STAFF REPORT: 12-11-2019 MEETING
APPLICATION NUMBER: 19-6526
ADDRESS: 1155 CLARK
HISTORIC DISTRICT: HUBBARD FARMS
APPLICANT: KOBLAR JACKSON
DATE OF COMPLETE APPLICATION: 11/5/2019
DATE OF STAFF SITE VISIT: 12/6/2019

SCOPE: REPLACE PORCH AT REAR ELEVATION

Historic District Commission Project Review Request—1155 Clark Street, Detroit, MI 48209

1155 Clark, current conditions

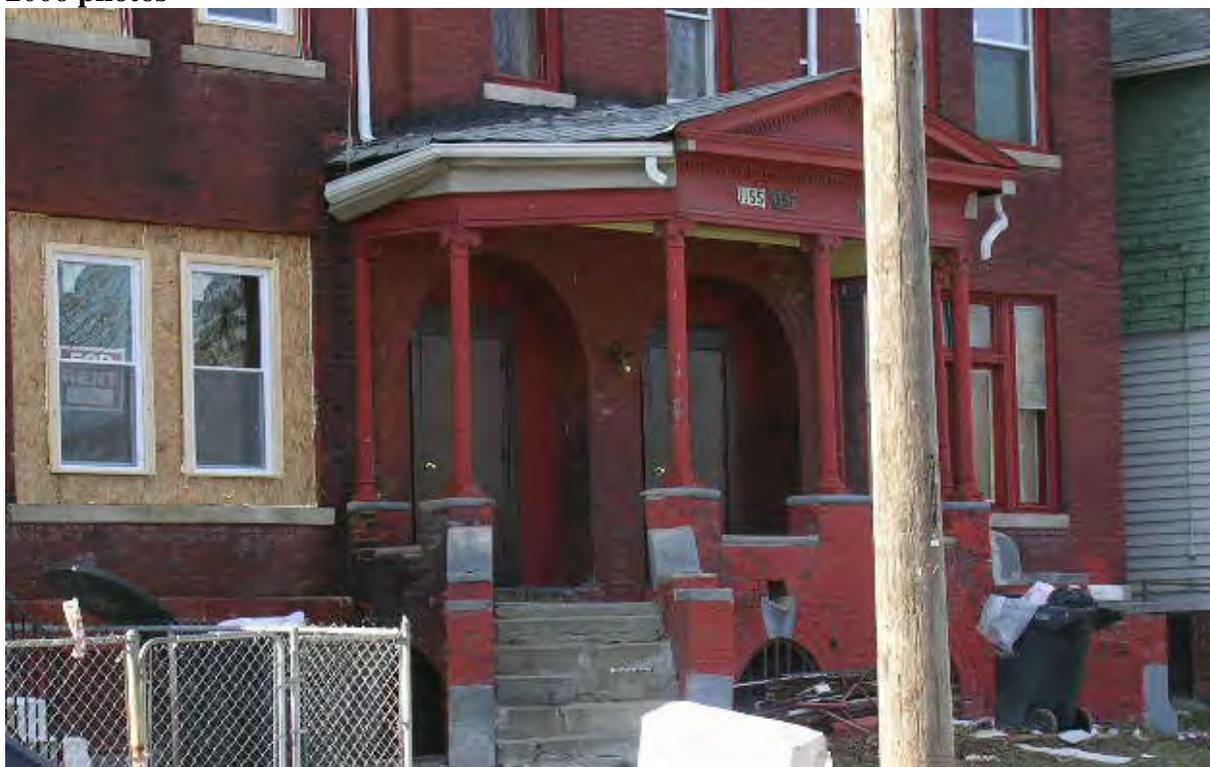
- The porch proposed for removal is historic age. However, it appears to be in poor conditions and appears to have been significantly modified over time. It is staff's opinion that the structure is not a character defining feature of this historic house.
- The submitted drawings indicate that the small deck which leads to the elevated door at the proposed new central stair enclosure does not have a railing. Building code will require that a railing be installed at this location
- A review of the property file revealed that original windows were removed, opening were partially infilled with plywood, and new vinyl windows were added without HDC approval and or permit in 2006. Please see the below scanned pictures of the 2006 violation:

It is staff's opinion that the proposed new porch not destroy historic materials that characterize the property and that the new work is compatible with the massing, size, scale, and architectural features to protect the historic integrity of the property and its environment. Staff therefore recommends that the Commission issue a Certificate of Appropriateness (COA) for the proposal because it meets the Secretary of the Interior's Standards for Rehabilitation, especially Standard #9) *New additions, exterior alterations, or related new construction shall not destroy historic materials that characterize the property. The new work shall be differentiated from the old and shall be compatible with the massing, size, scale, and architectural features to protect the historic integrity of the property and its environment.* However, staff does recommend that the Commission issue the COA with the following conditions:

- The new steel doors, gutters and downspouts shall be finished a color which complements the color of the home
- Regarding the new stair enclosure cladding, the applicant shall furnish a brick sample to HDC staff for review and approval. If staff determines that the cladding is appropriate to the building's historic character, the item will be forwarded to the commission for review at a future meeting
- On or before December 11, 2020, all wood components/elements of the porch shall be stained or painted a color which complements a color of the home.
